BETHANY TRACE LOT 39/40

PUMP TANK DESIGN

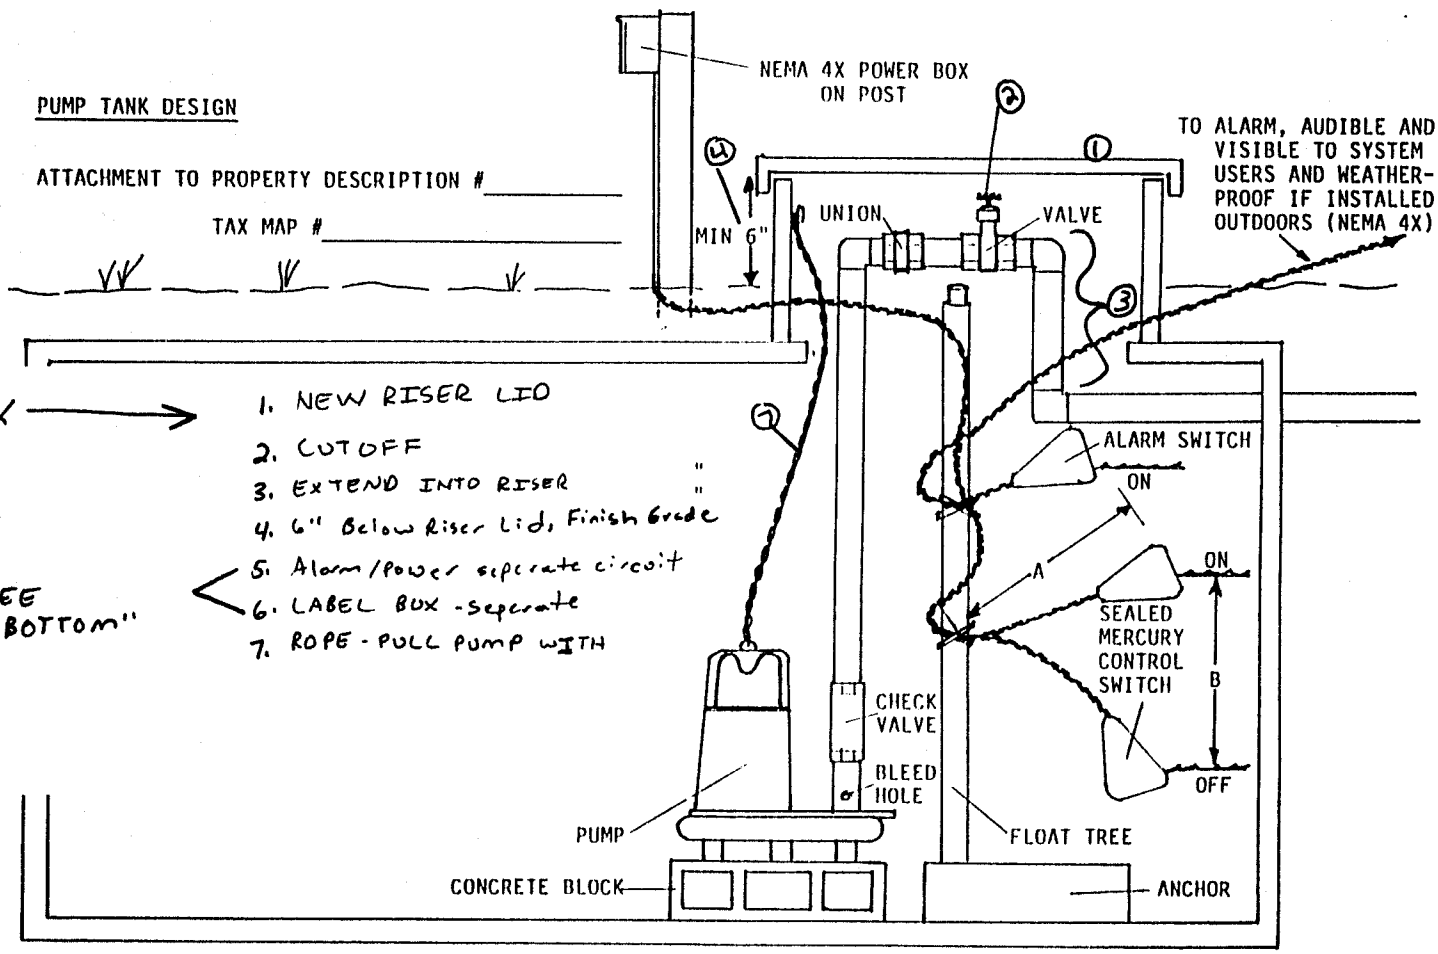
FIX →

1. NEW RISER LID
2. CUTOFF
3. EXTEND INTO RISER " "
4. 6" Below Riser Lid, Finish Grade
5. Alarm/Power seperate circuit
6. LABEL BOX - seperate
7. ROPE - PULL PUMP WITH

5. THE ALARM & PUMP POWER SUPPLY IS WIRED ON SAME CIRCUIT. It needs to be on two seperate circuits.

6. POWER BOX NEEDS TO BE LABELED with alarm & pump power supply.
